LLRF 28U racks requirements for XFEL XTL for L1, L2 & L3

03.09.2012 version 1.3

In some points compared to Schroff prototype 28U racks placed in extension hall (for ACC45, ACC67).

Fig. 1. Rear 'doors' should not be fixed with screws.

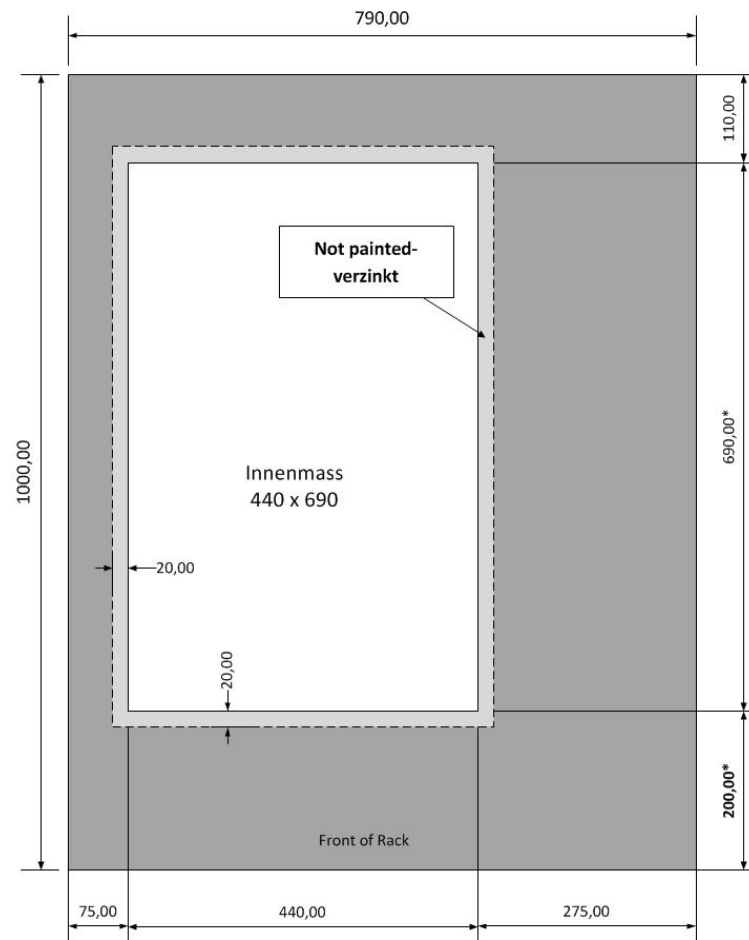
3. The rear doors which are removable should not be screwed, but with fixed attached handles which cannot be lost and is easy to open without additional tooling equipment – Fig. 1.

Fig. 2. Top cover opening for patch panel frame – right rack.

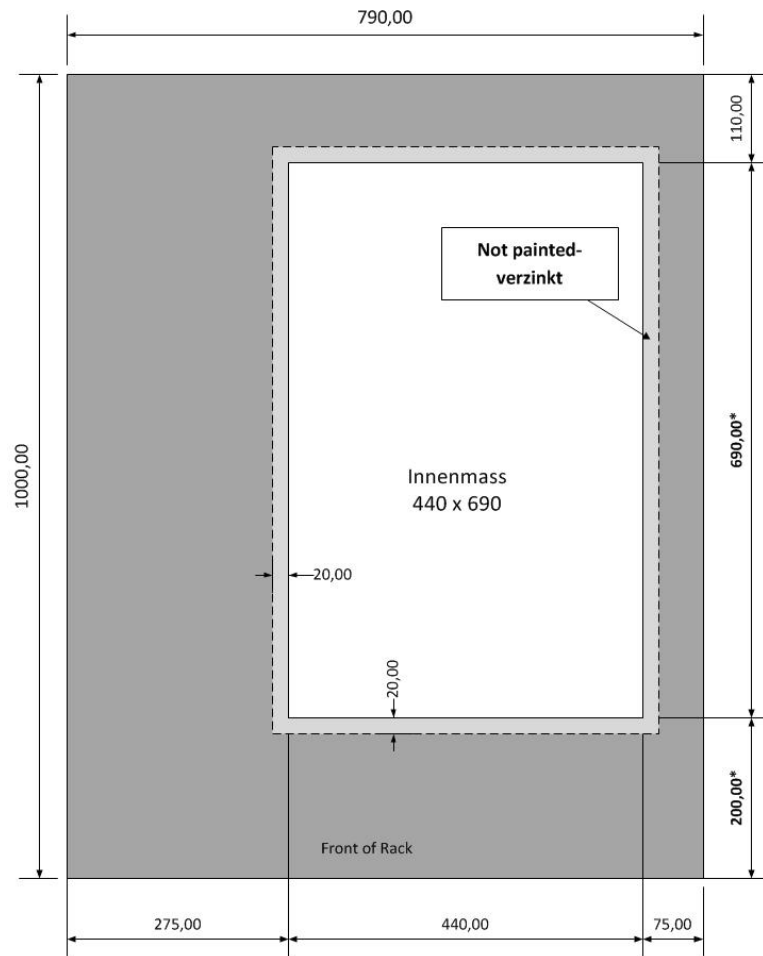
1. The top racks frame ('wanne') for LLRF patch panels dimensions will change slightly (the openings will be bigger in length due to change of the depths of the rack – depends on inner 19" rack design). New drawings are shown in Fig. 2, 3 & 4.

200*/690* - for the inner 19" chassis depth 600 mm

Fig. 7. Cooling Unit has no rubber dampers to prevent vibrations propagation.

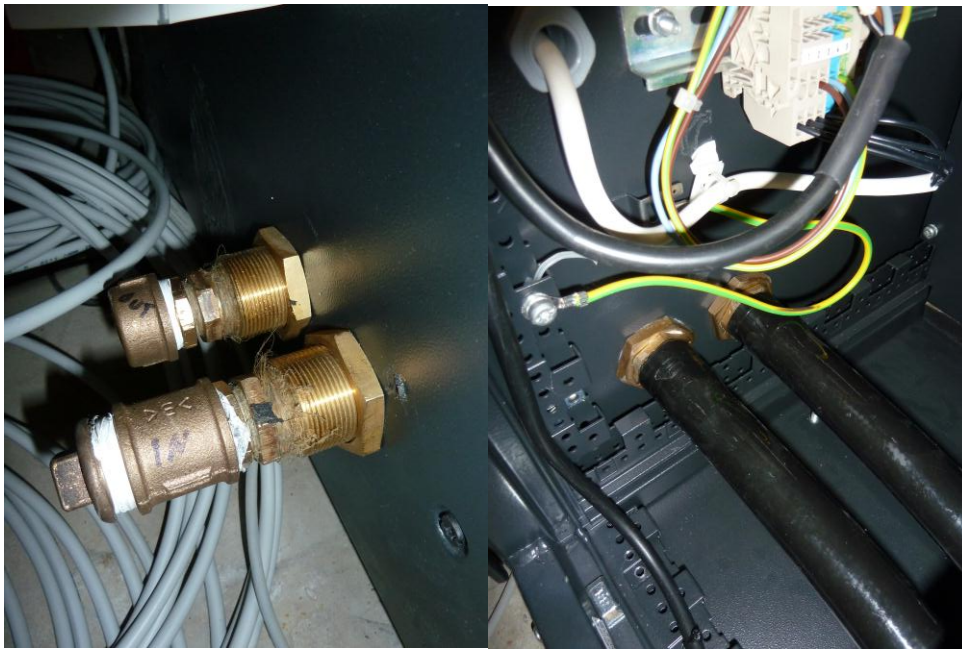
3. Cooling Unit fixed to the bottom with rubber dampers or steel springs and to the sides with rubber plates or dampers to reduce vibrations¹ – Fig. 7.
